PDPLANPMTD-2025/053400

PROPOSAL: Two Multiple Dwelling (One new & One Existing)

LOCATION: 262 Cambridge Road, Warrane

FURTHER INFORMATION FOR APPLICATION - PDPLANPMTD-2025/053400 - TWO MULTIPLE DWELLINGS (ONE EXISTING, ONE NEW) - 262 CAMBRIDGE ROAD, WARRANE

DRAWING: SITE PLAN

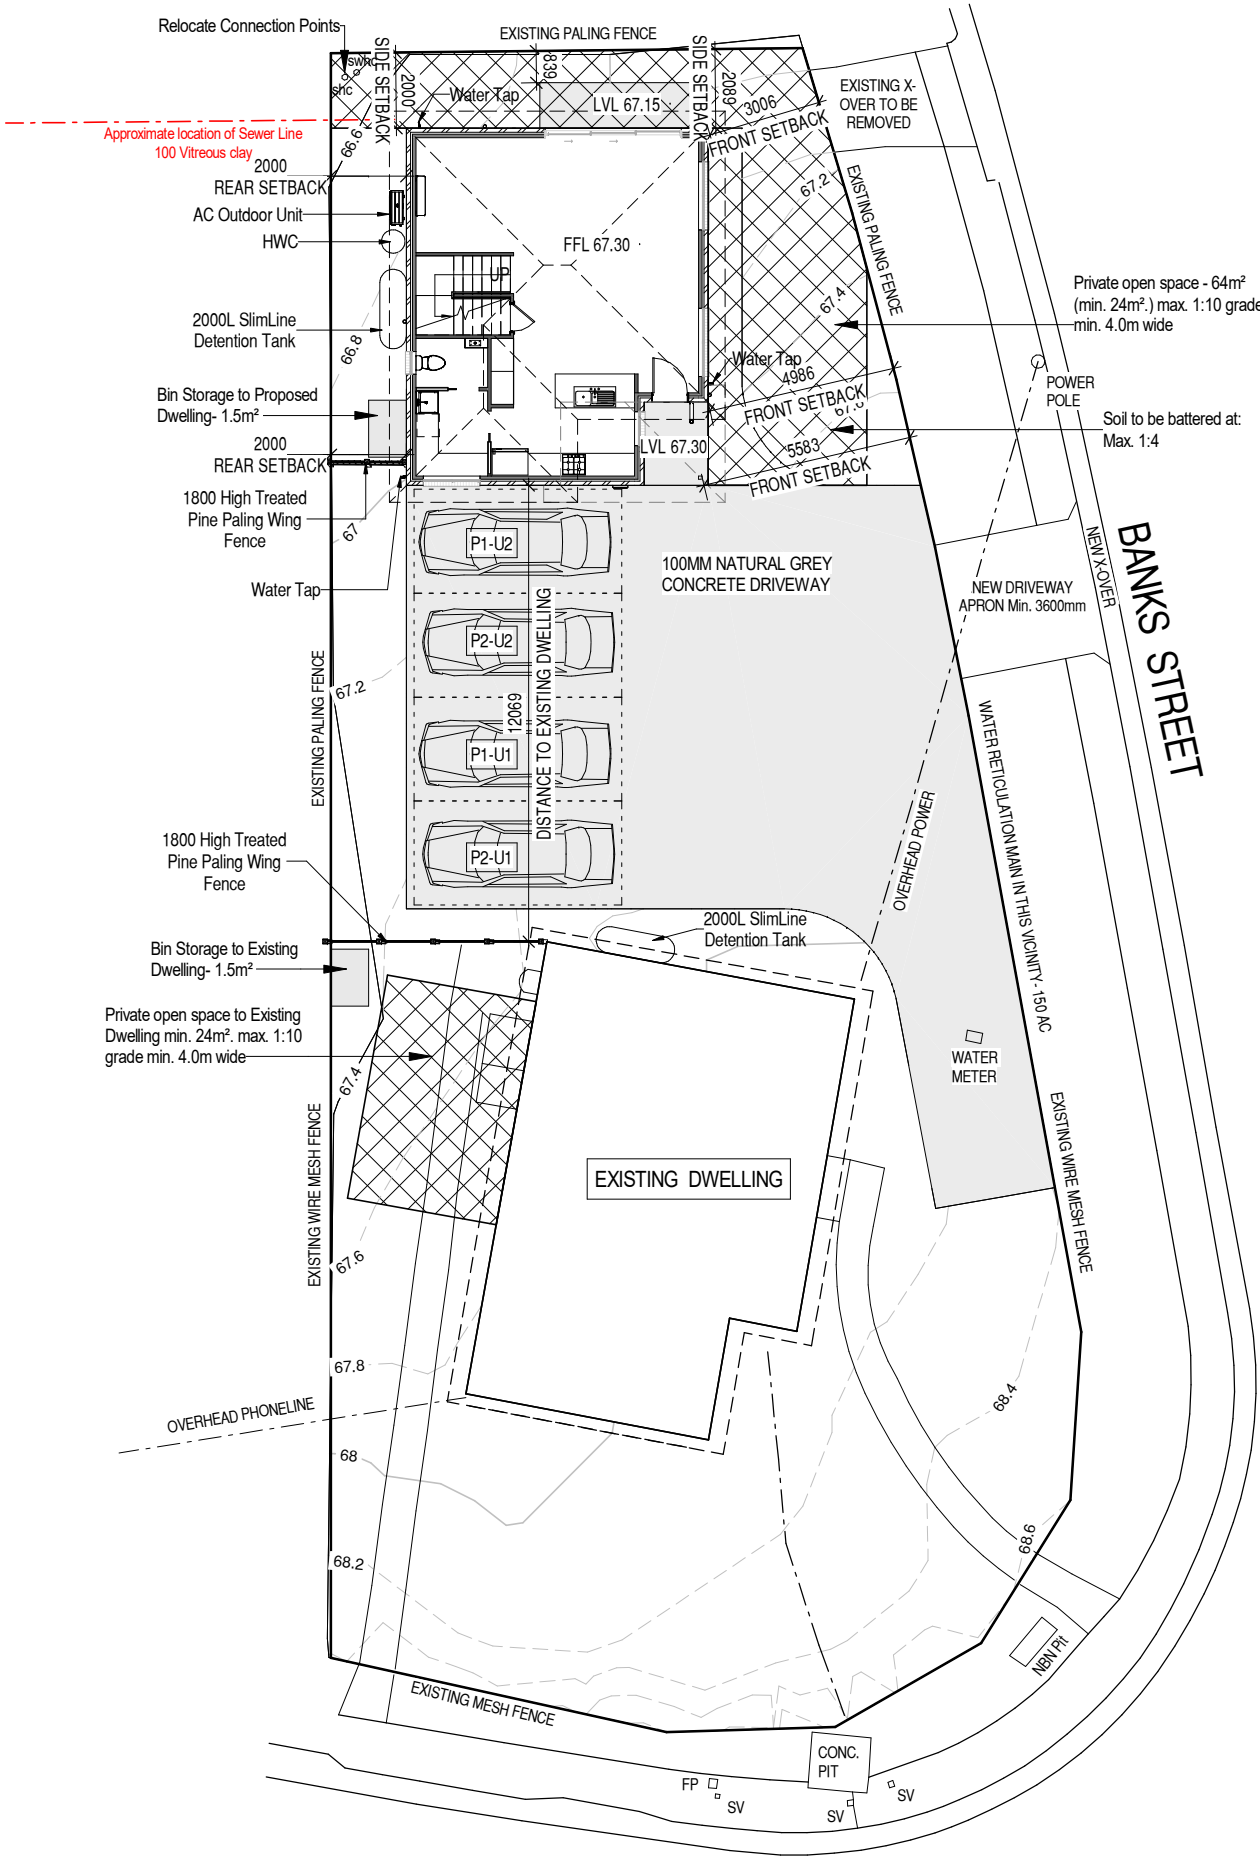
- Clause 8.4.3 A2 is not met, in that the proposed private open space for each dwelling is located between the frontage and the dwelling. In this instance, please provide a response to the corresponding performance criteria in relation to how each proposed private open space is conveniently located to the dwellings living area and is orientated to take advantage of sunlight.

- Clause 8.4.8 A1, please show on the site plan all proposed waste storage areas suitable to meet the above standard.

- It appears that there is a shortfall of one parking space as the proposal is missing the visitor park. Please either include the visitor park on the site plan or demonstrate compliance with the corresponding performance criteria C2.5.1 P1.2 in relation to how the proposed parking numbers meets the needs, scale and nature of the residential use.

- Please confirm if the engineering plans for the driveway are to be submitted with this planning application. In addition, please provide a 3.6m minimum crossover width as per TSD-R09-v3.

Response: The private open space for the existing dwelling as shown on the revised plans meets Acceptable Solution A2, as it has a minimum area of 24m² with a minimum horizontal dimension in excess of 4m, is not located between the dwelling and the frontage and has a gradient no greater than 1:10.

The proposed dwelling has a nominal area of contiguous private open space comprising 64m² wrapping around the north-west and north-east sides of the building, as shown in the revised plans. While part of the space is located between the dwelling and the frontage, an ample area of ~20m² is located between the dwelling and the northern side boundary. This space is directly accessed from the ground floor living area (a) and includes a patio that provides an integrated extension of the living space in a private location that is oriented for solar access (b). The extended private open space to the east of the dwelling is protected from exposure to the road by the existing paling fence, which is to be retained. The space provides a suitable area for outdoor living activities for the dwelling's residents and meets Performance Criterion P2, complying with the standard.

Response: Please refer to the bin storage areas for each dwelling, nominated on the revised plans.

Four car parking spaces is adequate for the proposed development for two multiple dwellings. Two dwellings is a low-intensity use, generating a requirement for one visitor car parking space as a result of required rounding; the rate of one space per four dwellings in accordance with Table C2.1 equates to only 0.5 of a space (a). The existing and proposed dwellings are modestly sized and each contain only three bedrooms (b), typically accommodating a family with shared transport. The site adjoins a high frequency bus route along Cambridge Road with inbound and outbound bus stops located within 40m, reducing potential reliance on car transport. The majority of dwellings in the locality are single dwellings; as such, there is no requirement for visitor parking for those dwellings (c). The provision of two on-site parking spaces for each dwelling is considered reasonable in this context. The proposal therefore meets Performance Criterion P1.2 and complies with the standard.

Response: Engineering plans will be submitted with the building application. A minimum crossover width of 3.6m is proposed, as shown in the revised plans.
